X3T13/D96104r4

2 May 1996

ATA Overlap Proposal

This document presents the detailed text changes to the ATA-3 document (X3T10/2008Dr6) for the Overlap proposal. It is based on the Overlap proposal submitted by Western Digital Corporation (X3T10/95-258r0) with the changes presented by Quantum Corporation (X3T10/95-257r0).

Figure xx - Example of command overlap with only one overlapping device

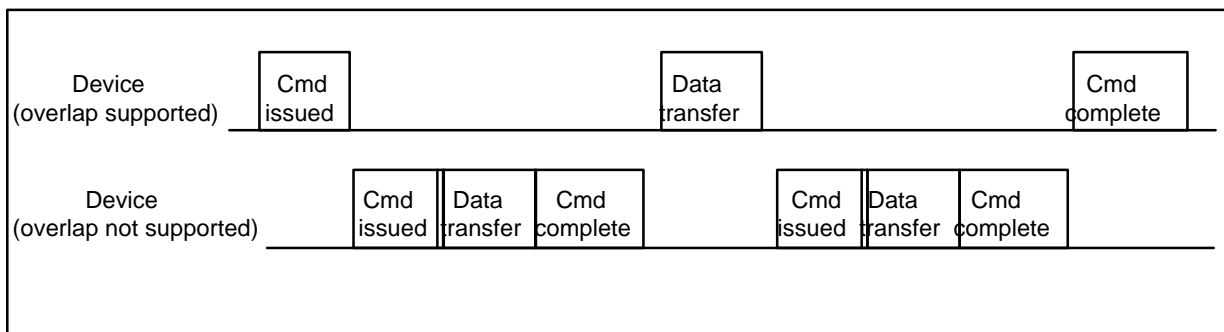
A device that supports the command overlap feature set may be configured on the bus with a device that does not support command overlap. For this configuration, the Overlapped INTRQ feature shall not be enabled in the device that supports command overlap. The host may issue an overlapped command to the device supporting that command, then select the other device, and issue it a command. Since the second device does not support overlap, the host must keep that device selected until the command completes and BSY is set to zero. The host may then select the first device and transfer the data associated with the overlapped command. Figure xx shows an example of this operation. In this example, the overlap device shall not assert INTRQ unless selected so the host must reselect the overlap device after completing the command with the non overlap device to be interrupted when the overlap device is ready to transfer the data.

Figure yy - Example of overlap with PACKET feature set device

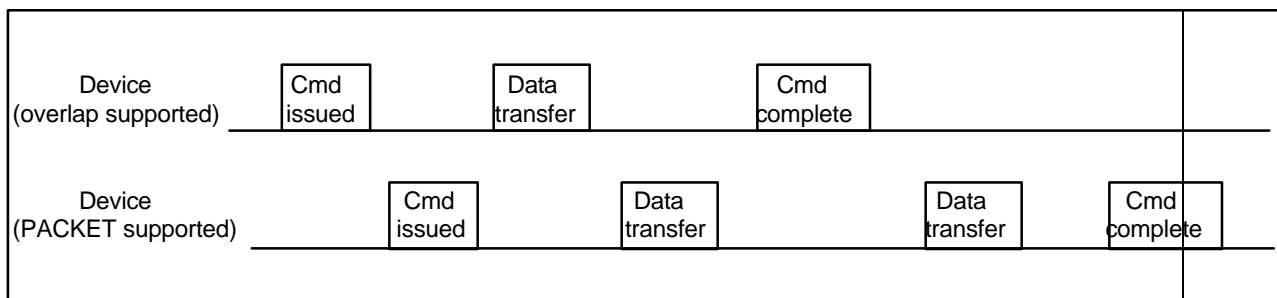
A device that supports the command overlap feature set may be configured on the bus with a device that does not support command overlap but supports the PACKET command feature set. For this configuration, the Overlapped INTRQ feature shall not be enabled in the device that supports command overlap. The host may issue an overlapped command to the device supporting that command, then select the other device, and issue it a command. If the Command is a PACKET command with overlap set, the host may then select the first device and transfer the data associated with the overlapped command. Having completed that command, the host may select the second device and complete its command. **Notice that the data transfer of the PACKET command may be split but the data transfer of the READ/WRITE DMA OVERLAP commands may not.** Figure yy shows an example of this operation. In this example, the devices shall not assert INTRQ unless selected so the host must reselect a device to be interrupted when the device is ready to transfer the data.

When two devices that support overlap are configured on a bus, Overlapped INTRQ shall be enabled. Overlapped commands may then be issued as shown in figure yy but the devices may interrupt the host when ready to transfer data regardless of device selection.

Figure aa - Command overlap and queuing state

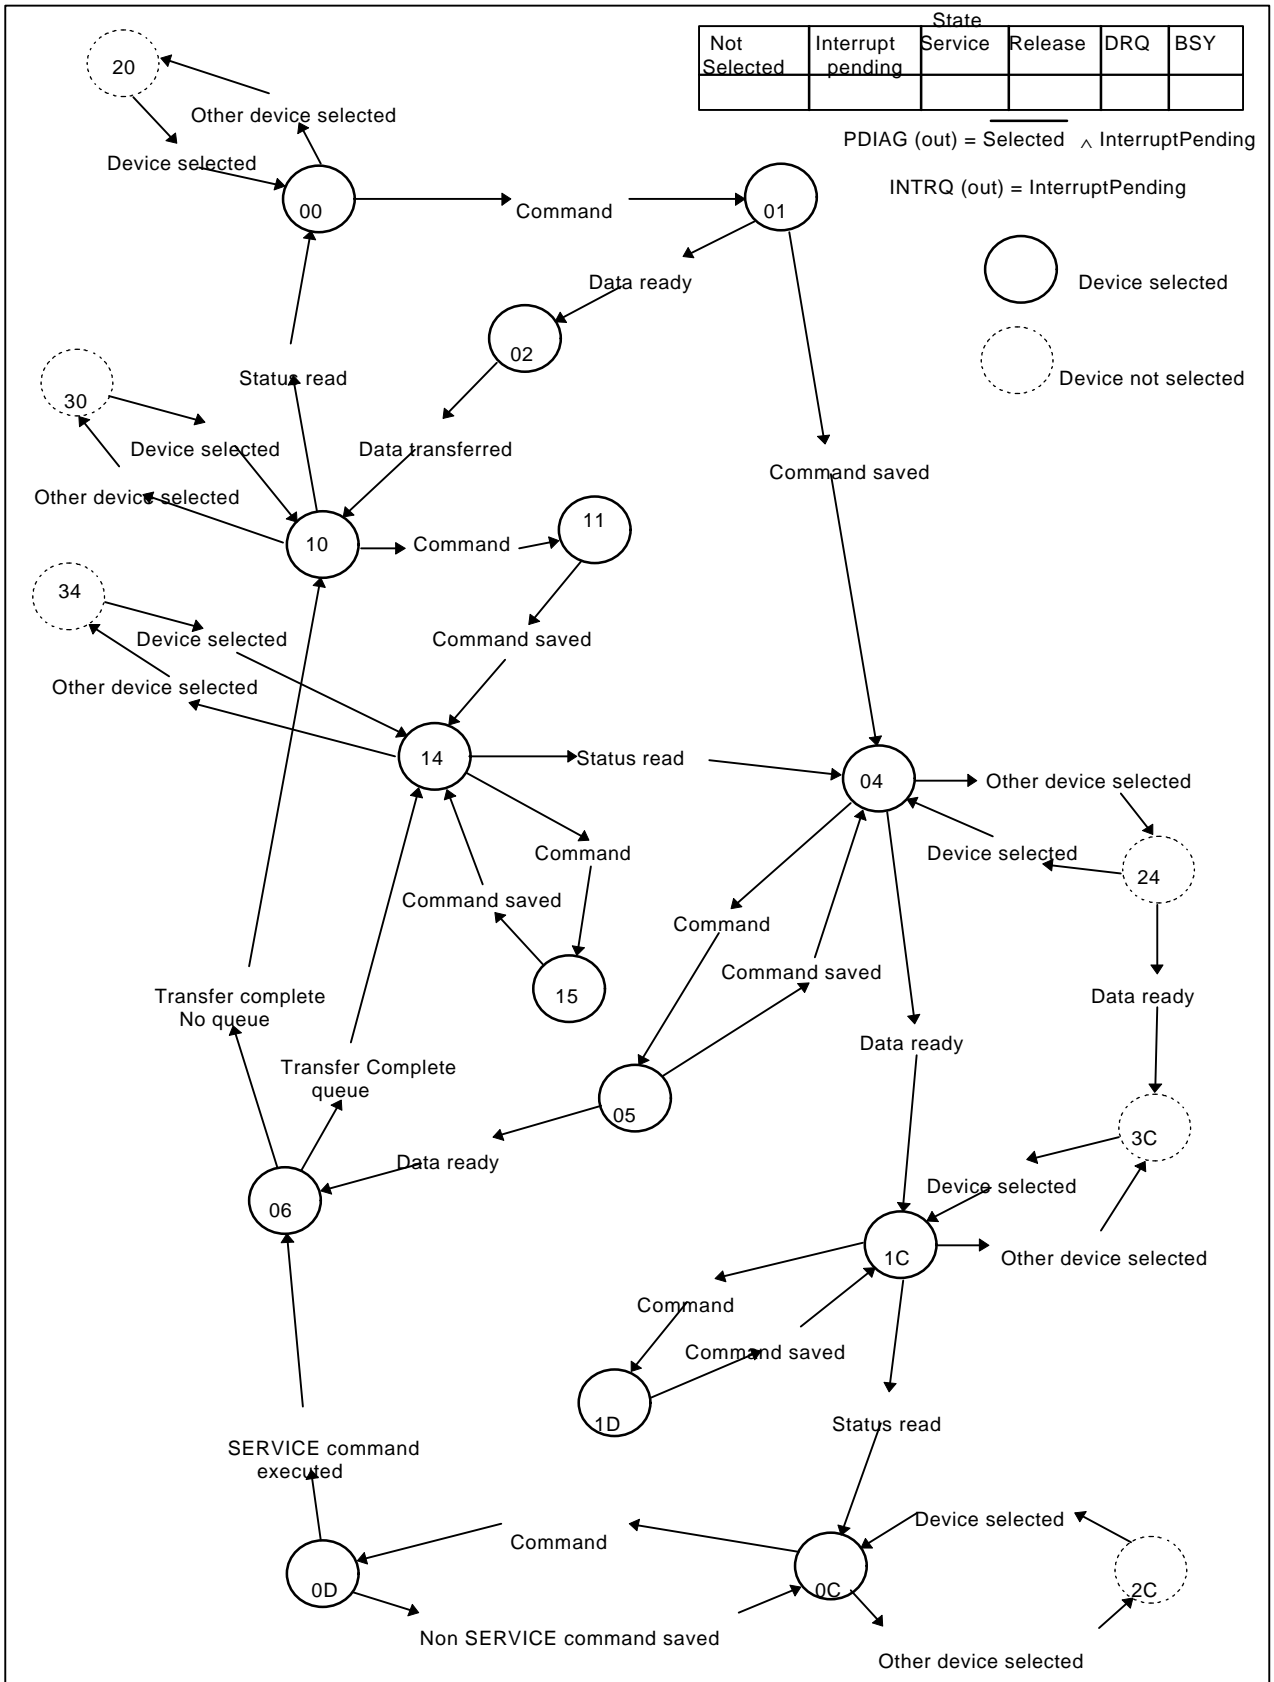
Figure aa is a state diagram for the protocol for command overlap and command queuing commands. Figure BB provides an example of commands overlapped to two devices. Figure cc provides an example of two commands queued to a single device.
